South Texas Project Units 1 & 2

STP Pilot Submittal for Risk-Informed Approach to Resolving GSI-191

Topical Area: Debris Generation

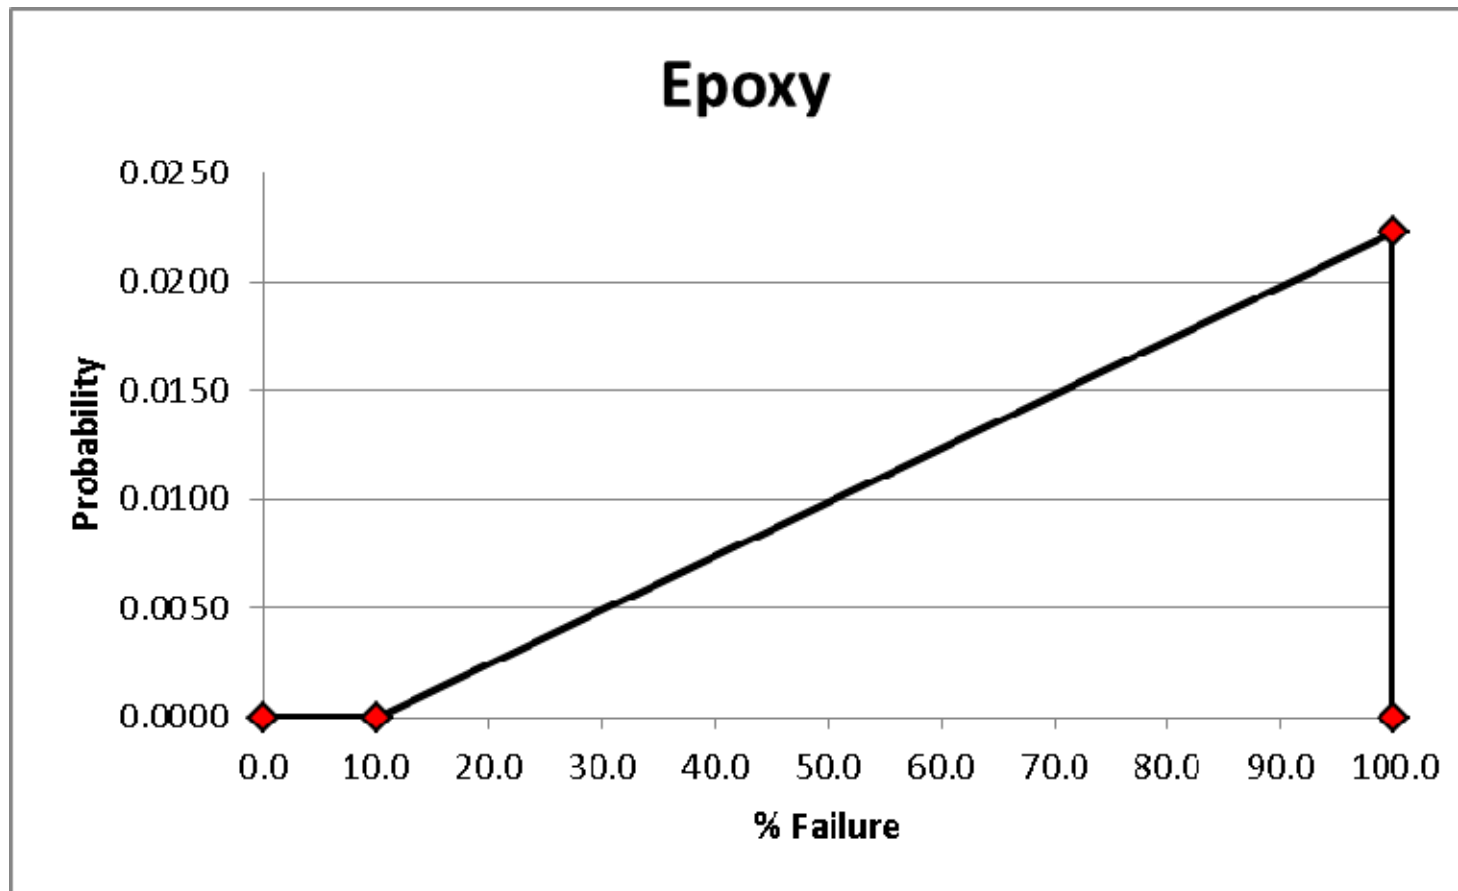
5.a.1) Failure timing, failure amounts, and debris characteristics of unqualified coatings.

- Input parameters used for failure timing, failure amounts, and characteristics of unqualified coatings are provided in Volume 3.
- Description of the method, basis, and assumptions used to develop the unqualified coatings input parameters is provided in a plant-specific unqualified coatings calculation.
- As an example of the detailed information that will be provided in the revised submittal:
